## 28 Ignition System

### Ignition cable connectors (new style)

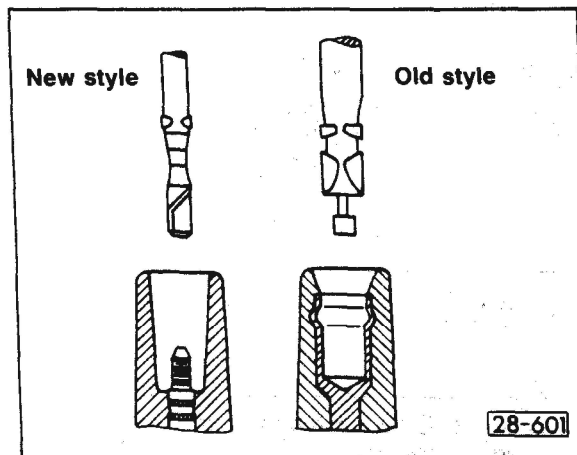
To assure tight connections, ignition cables now have new style (M4) connectors, as illustrated below.

Connections at distributor cap, ignition coil, interference suppressors and spark plugs have all been changed to new style.

Components with new style (M4) connectors are not interchangeable with old style. If replacement is required, install complete set with all connectors of same style.
